NORTH FULTON PUMP STATION UPGRADE
ADDENDUM ONE

Re: **07ITBNFPUMPSK-DB**
North Fulton Pump Station Upgrades

NORTH FULTON PUMP STATION UPGRADE
ADDENDUM TWO

NORTH FULTON STATIONUPGRADES
ADDENDUM THREE

MF-SK-1

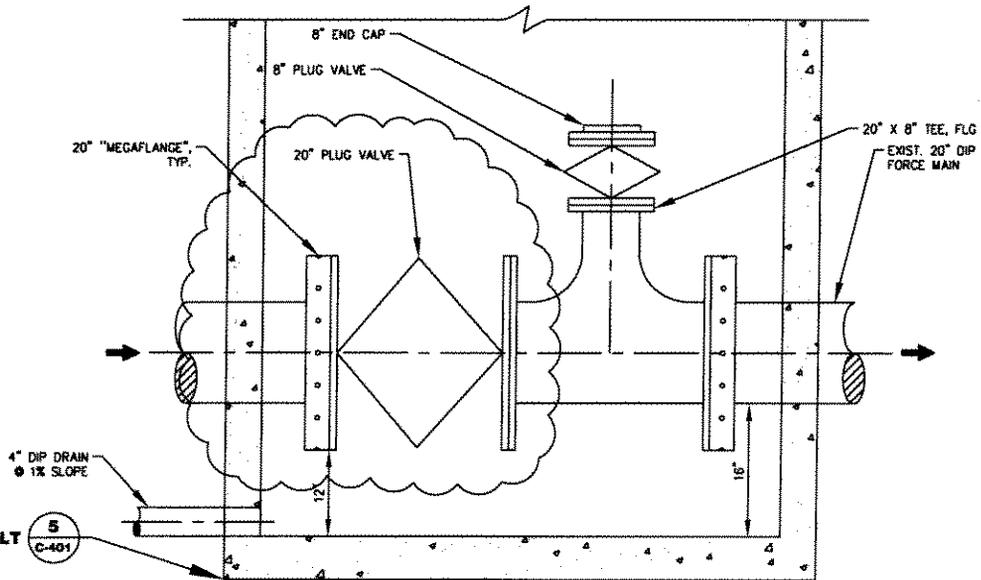
Modify Morgan Falls Drawings, Sheet C-401, in accordance with attached sketch
MF-SK-1.

NOTE: CONTRACTOR RESPONSIBLE FOR INTERCEPTING ALL WASTEWATER FLOWS DURING INSTALLATION OF PLUG VALVE AND BLIND FLANGE.

5 PRECAST CONCRETE VAULT
 C-401 SCALE: NOT TO SCALE

6 BLIND FLANGE
 C-401 SCALE: NOT TO SCALE

LC-SK-1

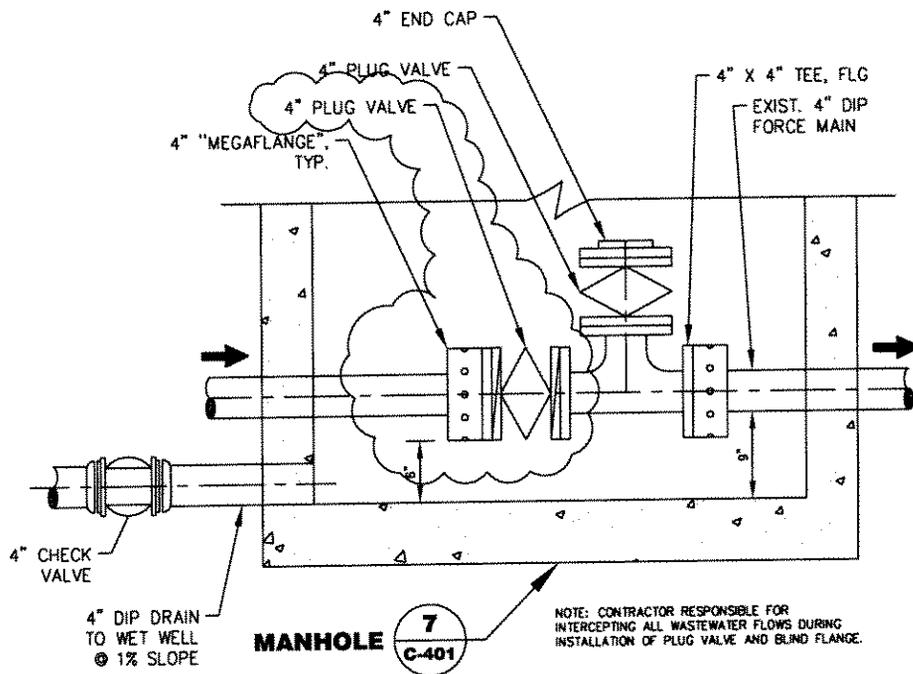
Modify Lake Charles Drawings, Sheet C-401, in accordance with attached sketch
LC-SK-1.

9 BLIND FLANGE
C-401 SCALE: NOT TO SCALE
